**ADDENDUM #5**

**C19010 – Cerone Division Emergency Generator Replacement**

**ISSUE DATE: JULY 17, 2019**

CERONE DIVISION EMERGENCY GENERATOR REPLACEMENT DETAILS			SHEET OF 33 DRAWING NO. A-4.1 REVISION
SAP NO.	CONTRACT NO. C19010	FILE LOCATION

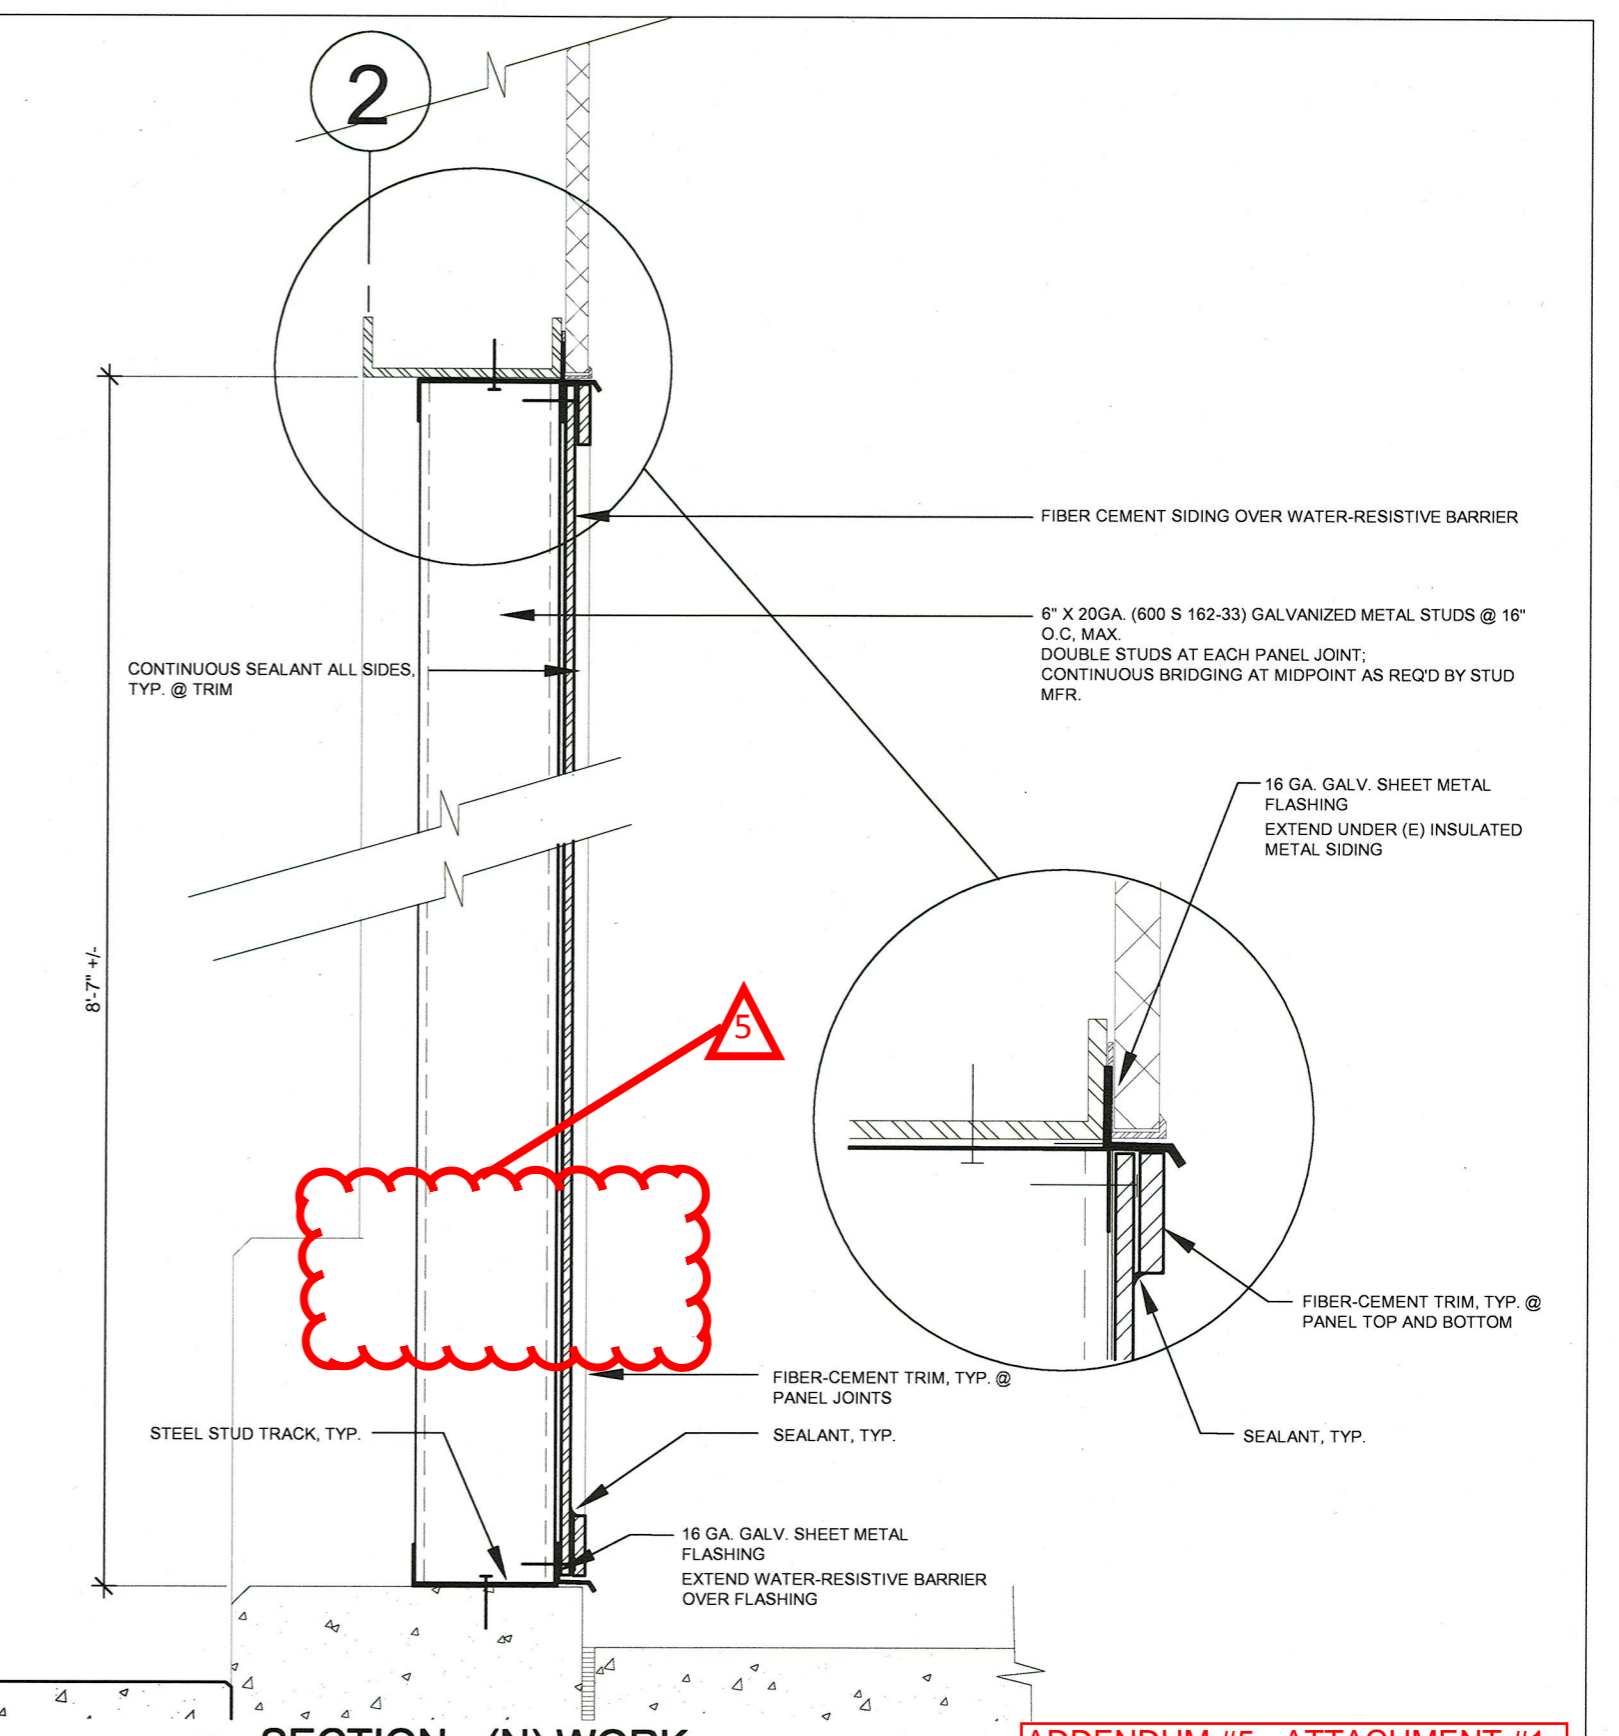
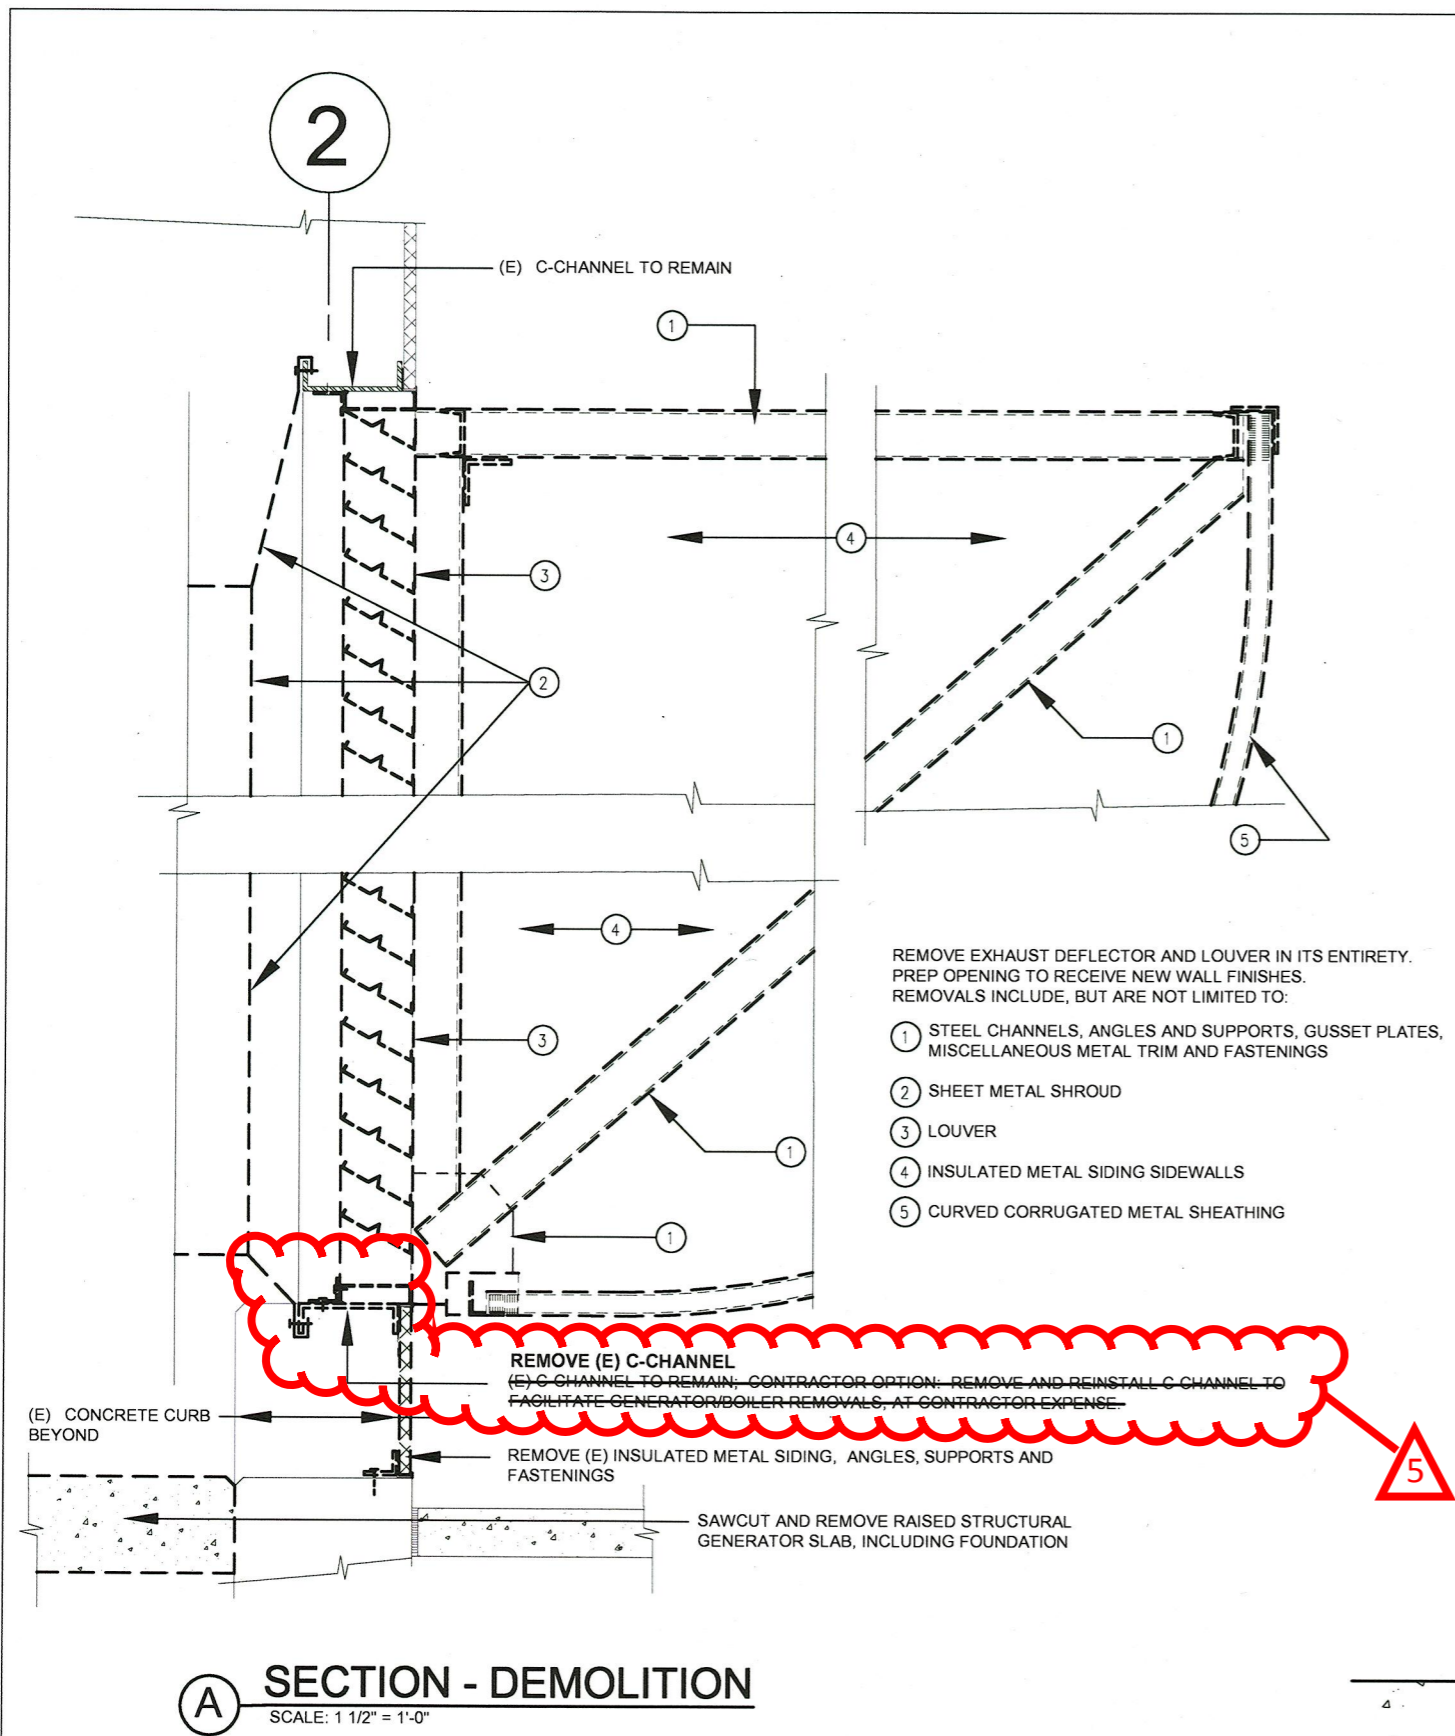
33. **ADD** General Note (2) to read:  
“2. A/R = AS REQUIRED.”
34. **DELETE** the following sheets, and **REPLACE** it with **Attachment #1** hereto.
  - Sheet 6 – Drawing No. A-4.1
  - Sheet 15 – Drawing No. E-2.1

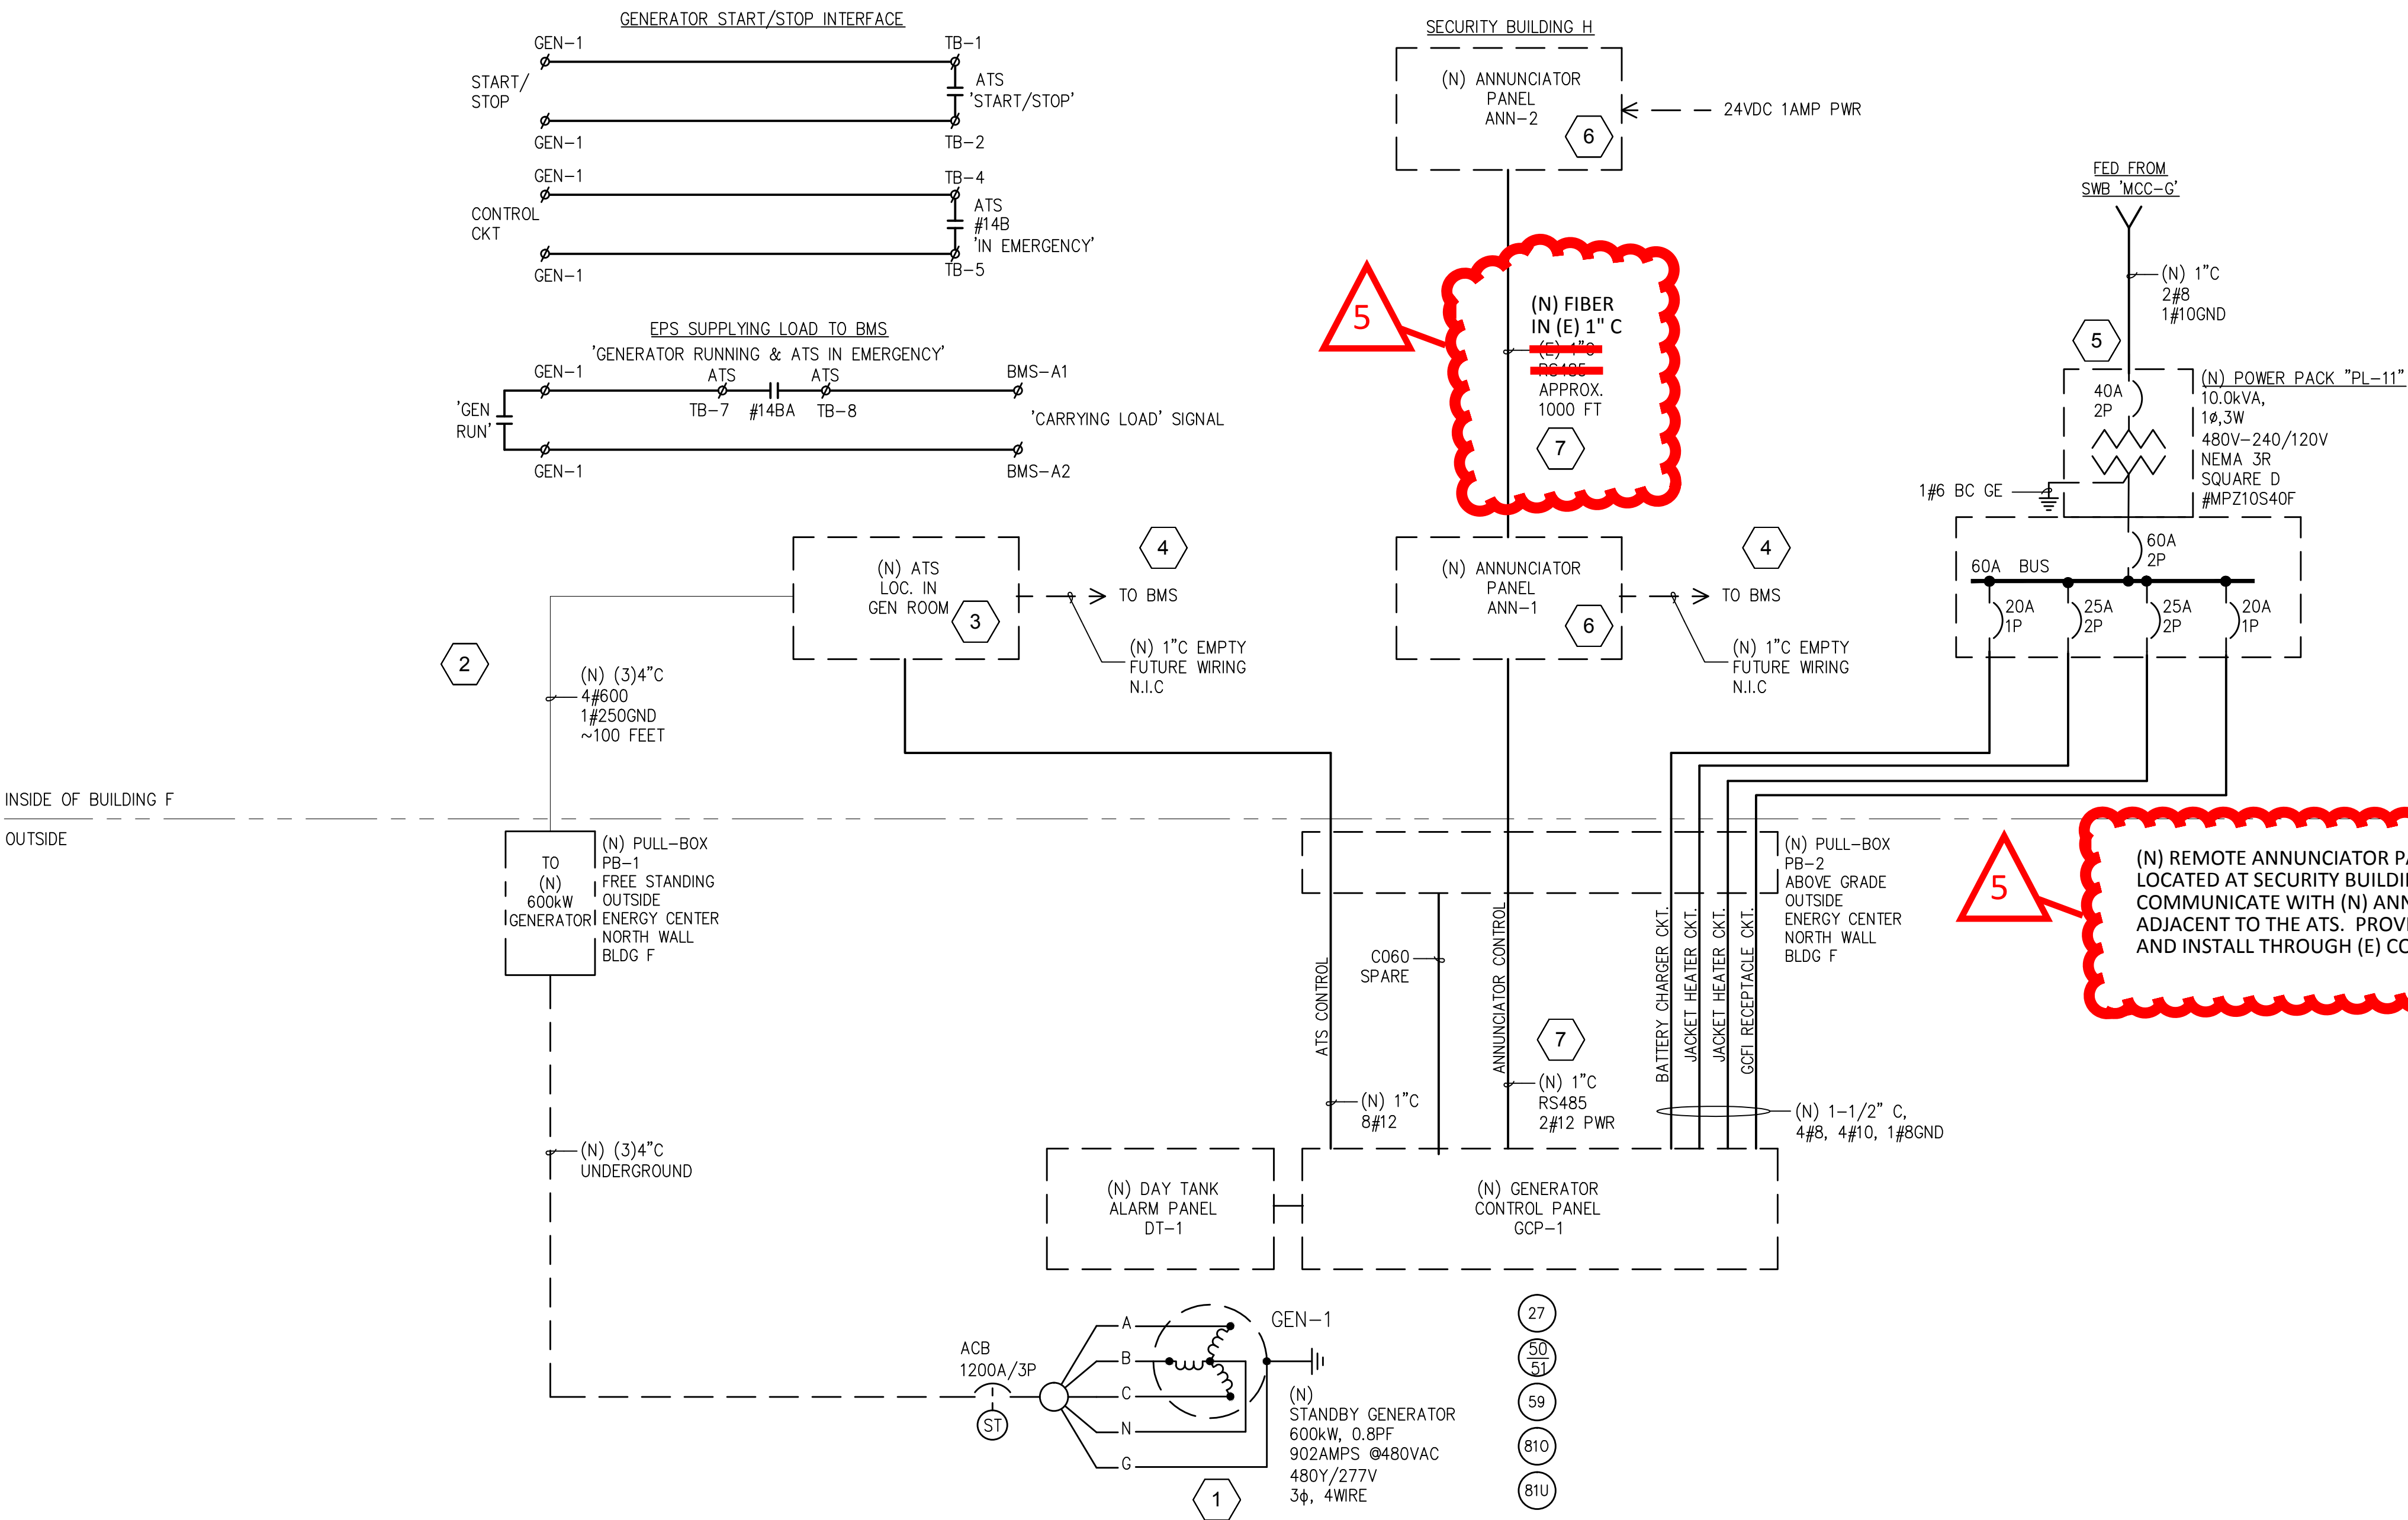
“PROVIDE (N) CONDUIT AND RS485 COMMUNICATION CABLE FROM THE (N) ANN-1 PANEL TO (E) FIBER OPTIC ENTRY POINT LOCATED IN BUILDING “F”. FROM THE (E) FIBER OPTIC ENTRY POINT, PROVIDE (N) FIBER THROUGH (E) CONDUIT TO THE (N) PANEL ANN-2 LOCATED IN SECURITY BUILDING “H”. REFER TO SH. E-2.1, KEYED NOTE 7.”

**7** (N) REMOTE ANNUNCIATOR PANEL ANN-2 LOCATED AT SECURITY BUILDING SHALL COMMUNICATE WITH ANN-1 LOCATED ADJACENT TO THE ATS, USING EXISTING FIBER CABLE. PROVIDE MEDIA CONVERTER (PERLE PSI-MOS-RS485W2/FO 850 E SERIAL TO FIBER CONVERTER OR EQUAL) AT EACH END AND USE JUMPER CABLES TO CONNECT (E) FIBERS.
